DATE: 03.27.2019

■ **CARROLL AT THE AVENUE [TRC Plan Review]**

☞ Initial Review Note ☞

ROUNDAABOUT

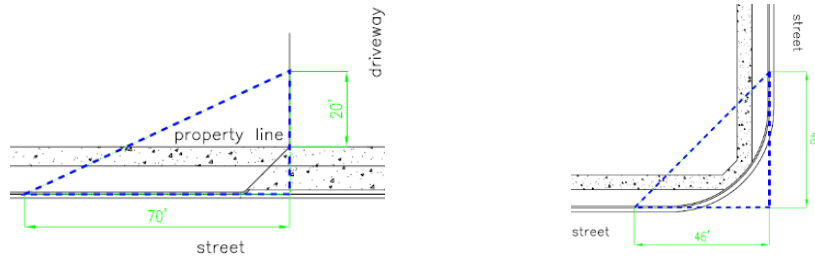
Roundabout design should be prepared by an engineer experienced with such and should consider geometric controls such as:

- Entry angle and offset to center as appropriate
- Entry, Circulating and exit speed-radius relationships
- Inscribed diameter/width consistent with design vehicle (Provide auto-turn analysis for the vehicle/s accessing this route).
- Provide Splitter Island where possible.
- Approach and departure sight distances.
- Sight distances across the center island and to the crosswalks.
- Appropriate signing and markings
- Sectional details.

This list is not inclusive and submittals should provide reasoning used for each parameter.
